# CITY PLANNING COMMISSION

- APPLICATION:
- A. Negative Declaration
  - B. Rezone 5.0± vacant acres from Agriculture (A) zone to Single Family Alternative (R-1A) zone
  - C. Tentative Map to divide 5.0± vacant acres into 70 condominium lots and one common lot
  - D. Special Permit to develop 70 condominium townhouses

PROPOSAL: The applicant is requesting the necessary entitlements to construct a 70 unit condominium complex with tot lot, pool, parking and common open area.

PROJECT EVALUATION: Staff has the following comments:

# EXHIBIT C - SITE PLAN

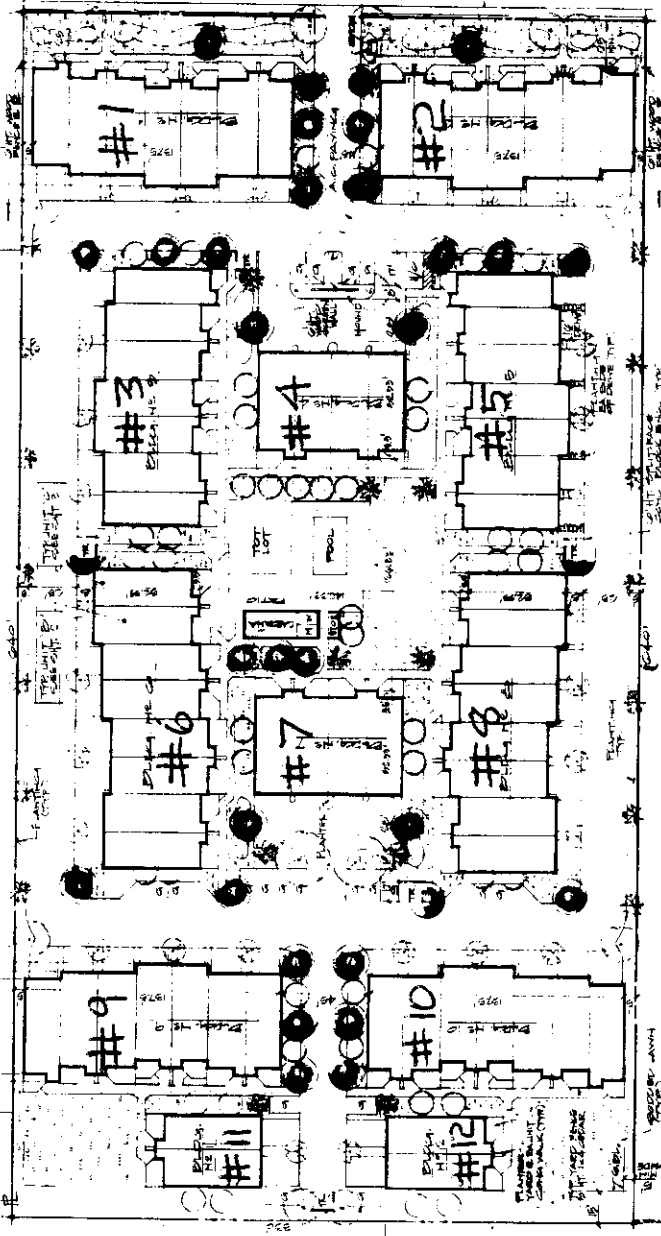
1. Rows of double car garages is viewed from the interior looped roadway is unacceptable. Buildings need to be broken up and oriented so that living areas view out over parking and access. The site plan does not provide security or sense of community due to the layout.

Planning staff noted that with two driveways as required by the Fire Marshall's and City Traffic Engineer off Taylor Street, Buildings 2 and 1 will require redesign and relocation. Other items staff noted related to the site plan follow:

1. A 6 foot high solid masonry wall is required along the north and south property lines where driveways or parking areas abut residentially zoned or used property unless a variance is granted by the Commission. A 6 foot high solid board fence is proposed.

2. Tandem parking spaces are not allowed.
3. The 25 foot landscape setback along Taylor Street should show 3 1/2 foot high undulating berms with street trees planted at a density of one tree per 20 lineal feet of frontage with staggered placement.

4. A decorative wrought iron 6 feet high security fence with locking gate is recommended, similar to Sacramento Place and Cederleaf along Taylor Street. This would also prevent parking on Taylor Street by residents.

5. The north and south property line planter areas adjacent to the looped driveway should be increased to 10 feet in width with shrubbery and evergreen trees planted on 20 feet centers.

6. A common recreation building and meeting room is recommended. The proposed cabana could be converted to a multi-purpose building for monthly homeowners meeting.

10. Since the units are to be owner occupied, staff recommends vehicle storage areas for boats, trailers, or other vehicles an owner may wish to store on the site. In the redesign, staff recommends a vehicie storage area being provided.

11. The redesign should incorporate as many elements of the Multiple Family Design Guidelines as possible.
12. The driveways need to be designed to commercial driveway standards, minimum 35 feet wide. Full street improvements need to be shown with centerline of Taylor Street identified on a revised site plan.
13. Any redesign of the condominium layout should provide a 25 feet setback for single story and 50 feet setback for two-story units from side and rear property lines. The proposed location of Building 10, five feet from the south property line, is actually adjacent to the service area for Eskaton's Skilled Nursing Home for the elderly.
14. The overall site plan does not relate well with Cederleaf apartments to the west nor to Eskaton's facility to the south. Analysis of land uses on the site should consider adjacent land uses or previously approved projects.

# EXHIBIT D - ELEVATIONS

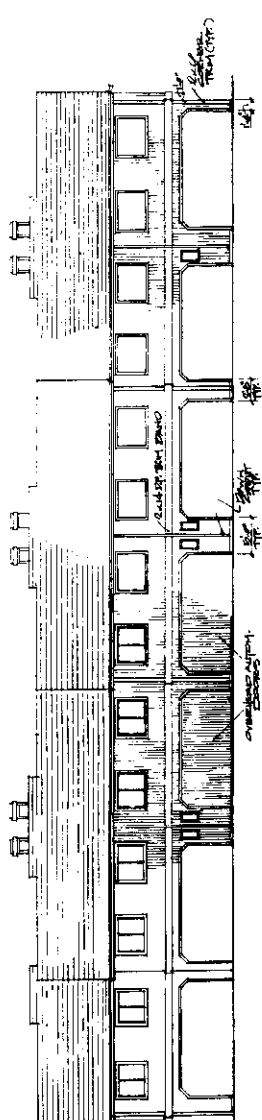
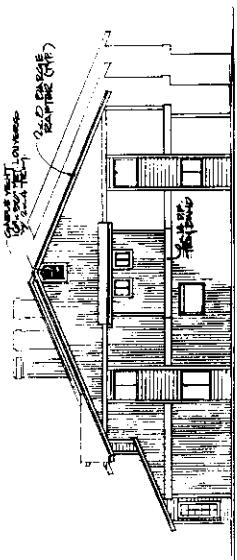
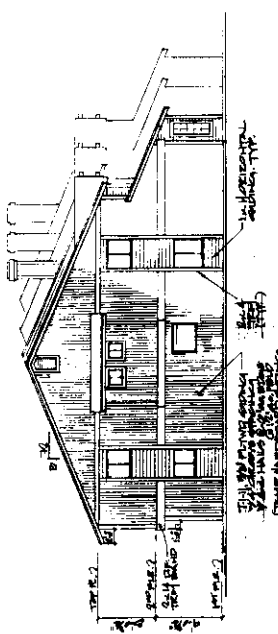
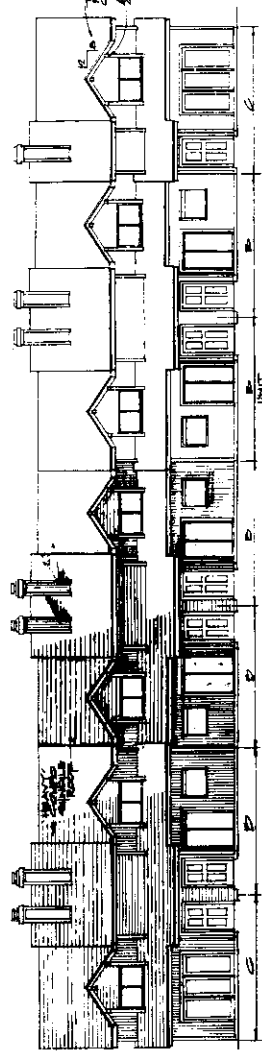
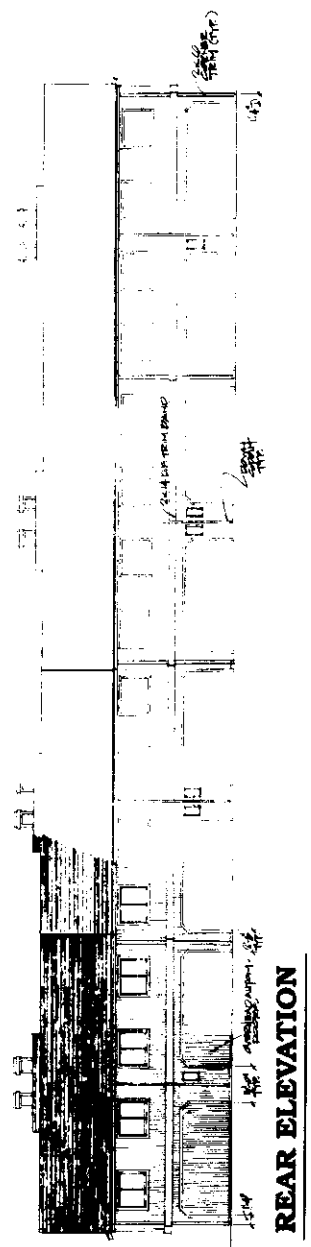
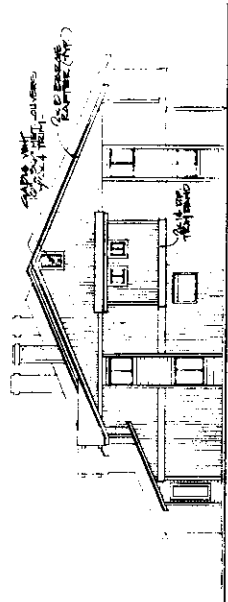
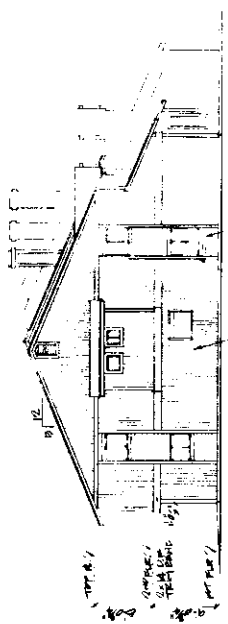
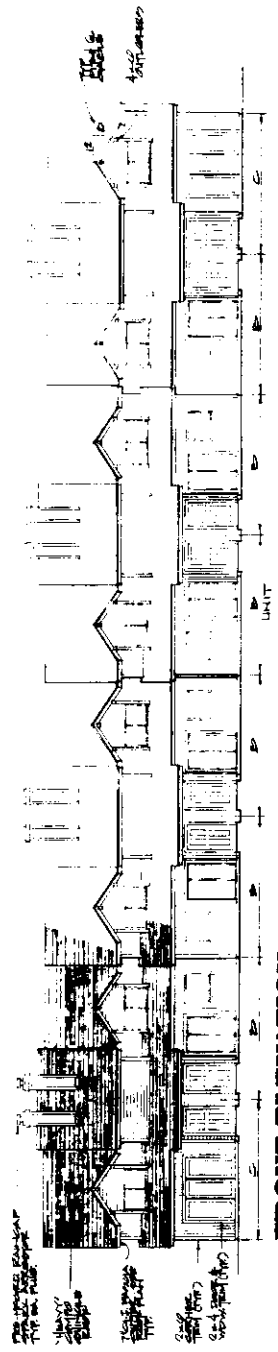
2. Exterior building materials of T-1-11 plywood siding should be upgraded with a mix of two or more exterior materials on the walls and use of wood trim elements. Roof material should be a minimum 25 year composition shingle.
3. The multiple family design guidelines should be reflected in the revised site plan.
